## ADDENDUM NO. 2

PROJECT: **ALBEMARLE BUILDING – FIRST FLOOR UPFIT – NC DEPT. OF ADMINISTRATION**  
**SCO ID#: 22-24323-01-CD / CODE: 42108 / ITEM: 4001**

FROM: DTW ARCHITECTS & PLANNERS, LTD.  
3333 Durham Chapel Hill Blvd, Suite D100  
DURHAM, NC 277078  
Phone: 919.317.4020 Fax: 919.317.4023 Email: [info@dtwarch.com](mailto:info@dtwarch.com)

Revisions	
1/6/23 ANR ADDENDUM #2	
Drawn	ANR
Checked	JDH
Date	DECEMBER 5, 2022
Sheet	E2.1

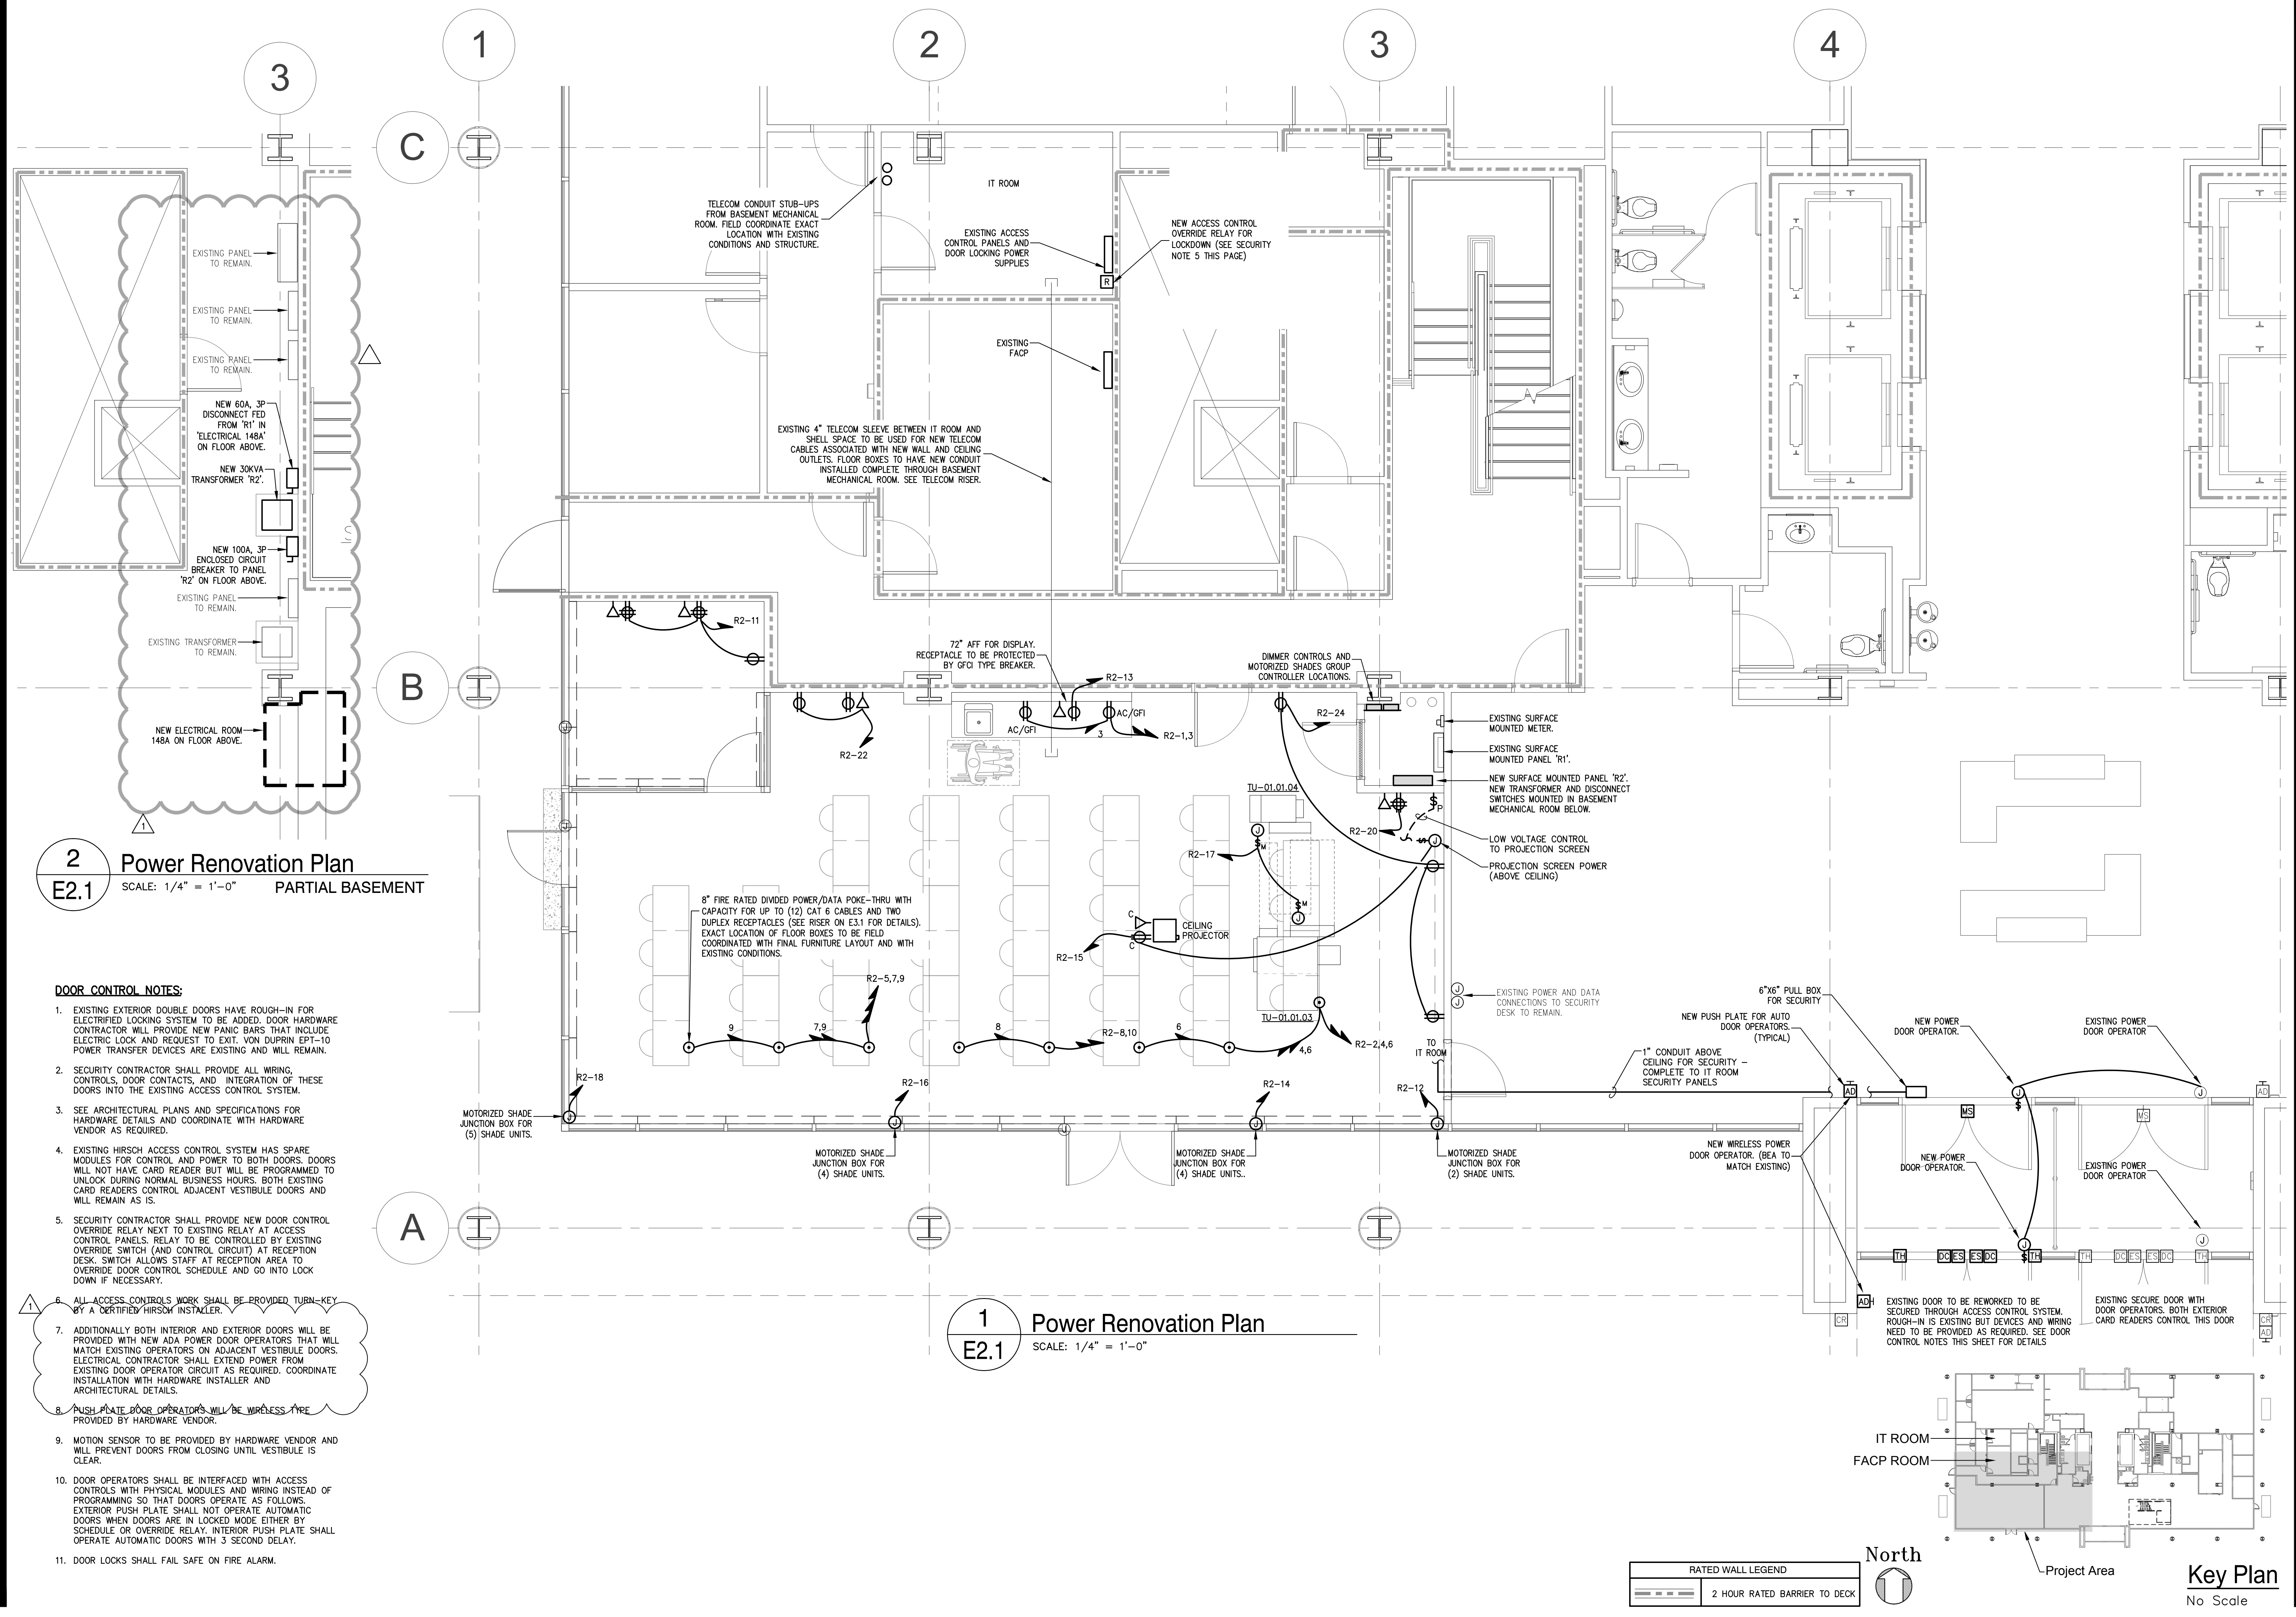
- f. Please clarify who is responsible for the following: Voice and Data, Security Access.
  - i. *Answer:*
    1. *Security Access Control: Please review sheet E2.1. Door control note 6 states that access control is to be provided turn-key. To clarify further ALL ACCESS CONTROL shown on the drawings is to be provided turn-key as part of the base bid contract.*

- h. Does the new door control at the reception desk control the new door operators or some other security locking device? Is it wireless?
  - i. *Answer: The new door operators will not be controlled directly from the reception desk. The access controls and door operators will be overridden by the existing override switch at the reception desk. This existing switch will lock down doors and disable door operators as noted on the plans. This existing access control switch is not wireless.*

- i. Can we feed power to the new operators by running exposed conduit then capping the aluminum tube to conceal the conduit?
  - i. *Answer: The plans show the power for the new door operators to be on the same circuit as the existing door operators however extension of the circuit should be from external junction boxes and not through the existing operators. The conduit needs to be concealed.*

- j. Can we assume that there is an existing conduit to the reception desk that can be used for door operator control wiring?
  - i. *Answer: The plans indicate that the existing door override control circuit shall be used to control a new override relay for the new doors. This relay shall be installed next to the existing override relay in the IT room.*

- SECURITY CONTRACTOR SHALL PROVIDE NEW DOOR CONTROL OVERRIDE RELAY NEXT TO EXISTING RELAY AT ACCESS CONTROL PANELS. RELAY TO BE CONTROLLED BY EXISTING OVERRIDE SWITCH (AND CONTROL CIRCUIT) AT RECEPTION DESK. SWITCH ALLOWS STAFF AT RECEPTION AREA TO OVERRIDE DOOR CONTROL SCHEDULE AND GO INTO LOCK DOWN IF NECESSARY.

- ALL ACCESS CONTROLS WORK SHALL BE PROVIDED TURN-KEY BY A CERTIFIED HIRSCH INSTALLER.
- ADDITIONALLY BOTH INTERIOR AND EXTERIOR DOORS WILL BE PROVIDED WITH NEW ADA POWER DOOR OPERATORS THAT WILL MATCH EXISTING OPERATORS ON ADJACENT VESTIBULE DOORS. ELECTRICAL CONTRACTOR SHALL EXTEND POWER FROM EXISTING DOOR OPERATOR CIRCUIT AS REQUIRED. COORDINATE INSTALLATION WITH HARDWARE INSTALLER AND ARCHITECTURAL DETAILS.
